**METROPOLITAN GOVERNMENT OF NASHVILLE AND DAVIDSON COUNTY**

**STAFF RECOMMENDATION**  
**1321-1327 5<sup>th</sup> Avenue North**  
**November 14, 2012**

**Application:** New construction-infill  
**District:** Germantown Historic Preservation Zoning Overlay  
**Council District:** 19  
**Map and Parcel Number:** 08209007500, 08209007400, 08209007300, 08209007200  
**Applicant:** Bryan Bowen Architects, P.C.  
**Project Lead:** Robin Zeigler, robin.zeigler@nashville.gov

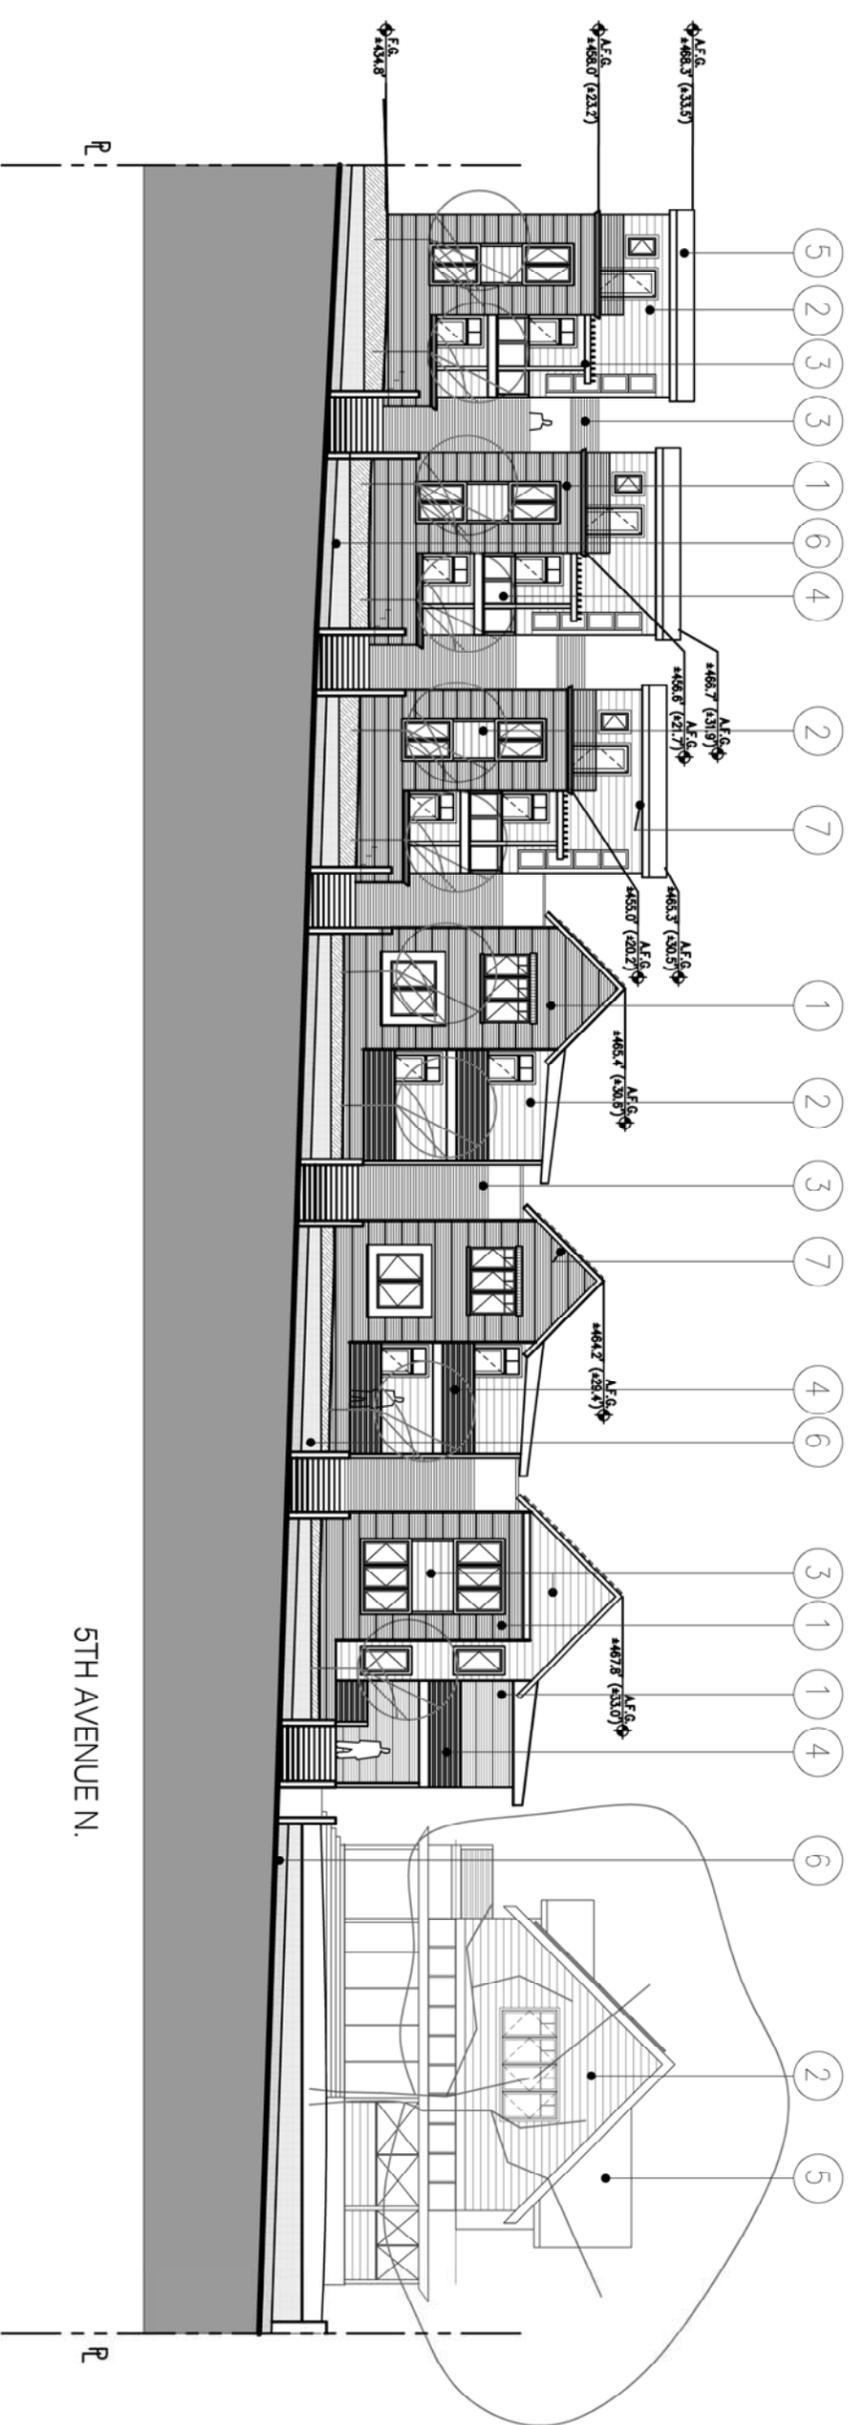
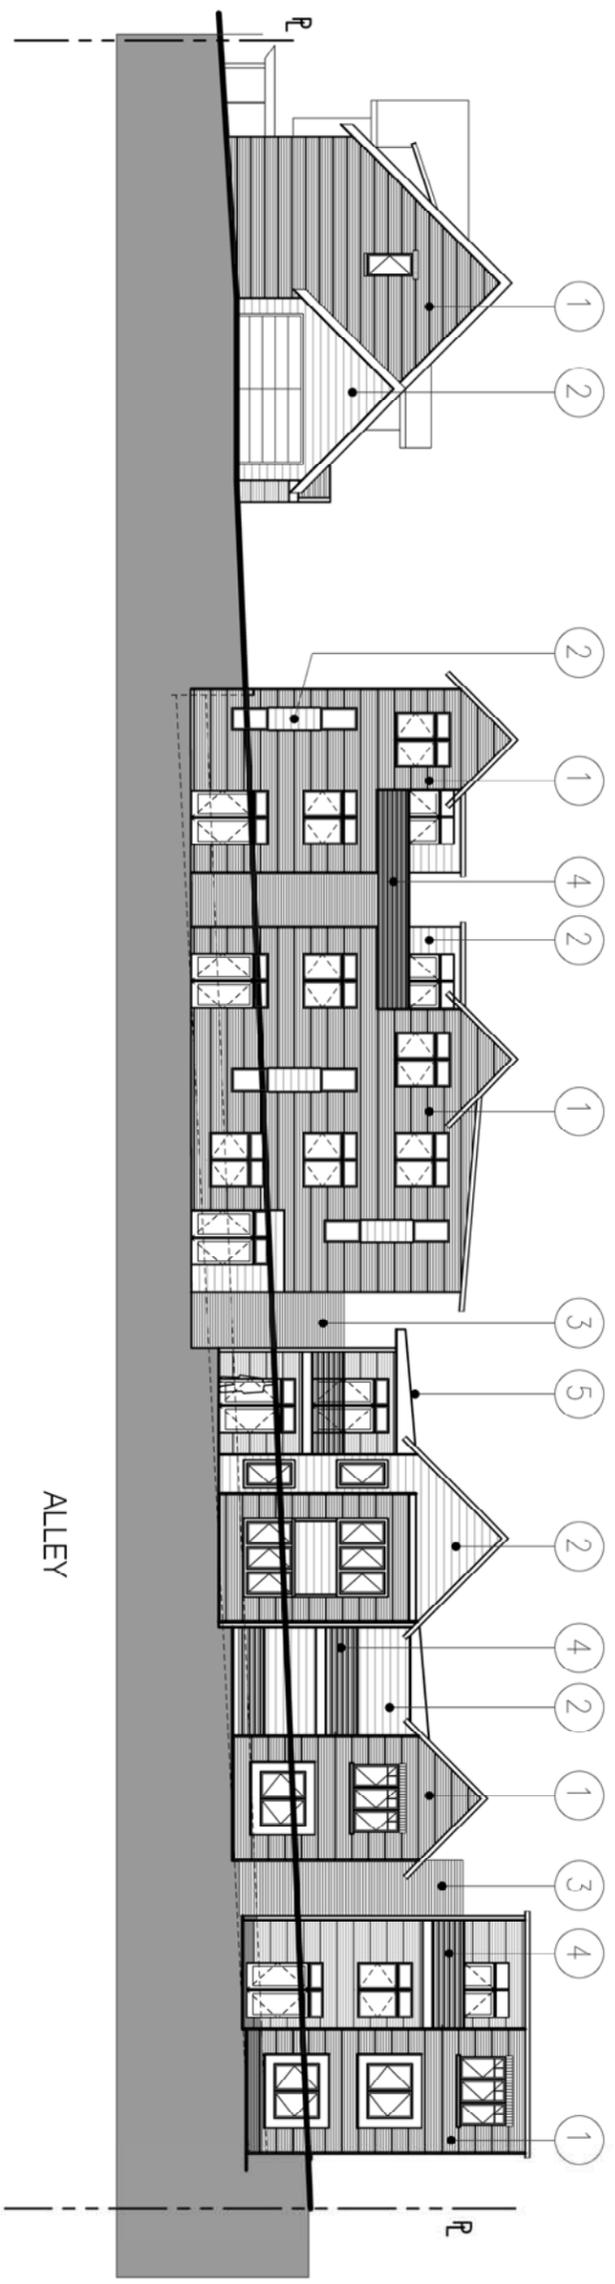
The actual primary entrance for the C building will be towards the interior of the lot and there is also an entrance on the Taylor Street side. The guidelines require that the orientation of buildings be consistent with the historic context which have *primary* entrances facing the street. In this case, a low brick wall extends in front of the Taylor Street entrance. This feature and the lack of windows gives this entrance the appearance of a secondary entrance. Staff recommends a design for the Taylor Street side of the C building that includes a visually primary entrance. With this condition met, the project meets section 2.2.2 of the design guidelines.

Building C is approximately forty feet (40') tall from grade at its tallest point. Staff finds this height to be appropriate as the additional height beyond the thirty-five foot maximum is due to a change in grade. Unlike the rest of the project, C building mimics a single-family residential building but is out of scale for the single-family historic context. Staff recommends a smaller bay to meet section 2.2.3.1 and additional windows on the first and second floors in lieu of or in addition to the clerestory windows to meet section 2.2.3.3.

Doors & Windows: The 5<sup>th</sup> Avenue North doors will be half-light but the material is unknown. Railings and details of the aluminum clad or fiberglass windows are also unknown. The majority of windows are twice as tall as they are wide, some with vertically accentuated with panels between lower and upper windows. The rhythm of openings matches the rhythm found in historic buildings in the overlay. There are two exceptions: The first floor windows of the two side-gabled central buildings facing 5<sup>th</sup> Avenue North do not have the same proportion as historic windows in the neighborhood. In addition, there is a lack of windows on the first and second levels of building C.

All glass is clear. Staff recommends that the noted windows of the 5<sup>th</sup> Avenue elevations be taller than they are wide and additional windows be added to both levels of the Taylor Street side of building C.

- The Taylor Street entrance of Building C be designed to appear as a primary entrance;
- The Taylor Street side of Building C be designed with a bay more in scale with the building and the context and with additional windows on both levels; and
- The applicant obtains final approval from staff for the specifications of all materials.
